Proposal for amendment 3 UN Global Technical Regulation No. 9 (Pedestrian safety)

Submitted by the expert from the European Commission

The text reproduced below was prepared by the expert from the European Commission to clarify provisions of the headform tests of UN GTR No. 9. It supersedes ECE/TRANS/WP.29/GRSP/2014/5.

"Figure 6A
Measuring point in the vertical longitudinal plane through the centre of the headform
impactor (see paragraph 3.20.1. 3.21.1) ²

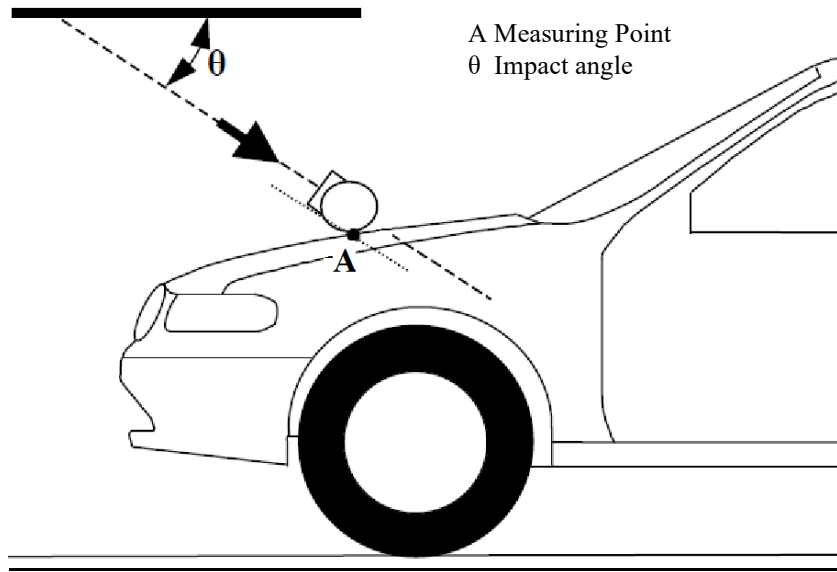
3.21.1. "Measuring point" for the headform test means a point on the vehicle's outer surface selected for assessment. The measuring point is where the headform's profile contacts the vehicle's outer surface cross section in a vertical longitudinal plane through the center of gravity of the headform (see Figure 6A).

Insert new Figures 6A and 6B, to read:

Figure 6B
Measuring point in the vertical longitudinal plane through the central axis of the
legform impactor (see paragraph 3.20.2. 3.21.2)

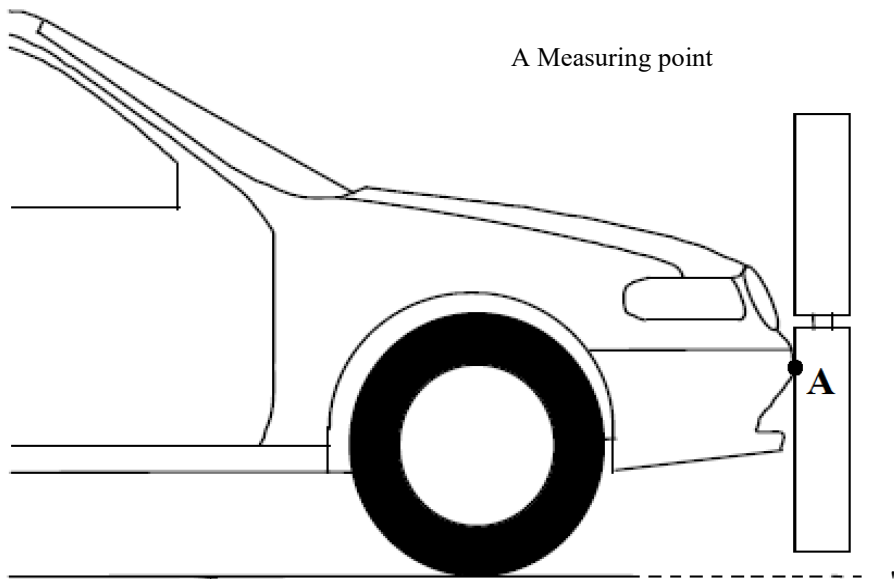
3.21.2. "Measuring point" for the lower legform to bumper test and the upper legform to bumper test is located in the vertical longitudinal plane through the central axis of the impactor (see Figure 6B)."

"Figure 11

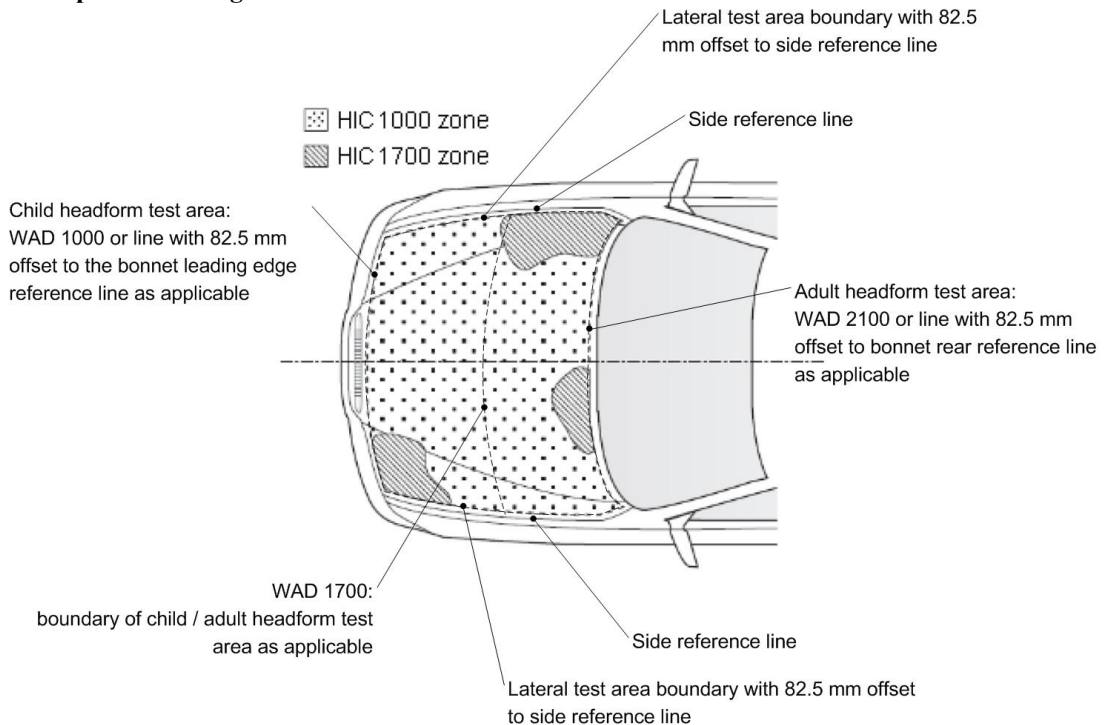
"5.2.4.1. The manufacturer shall identify the zones of the bonnet top **test area** where the HIC must not exceed 1,000 (HIC1000 Zone) or 1,700 (HIC1700 Zone) (see Figure 11)."

Figure 11(former), shall be deleted

Insert new Figure 11, to read:
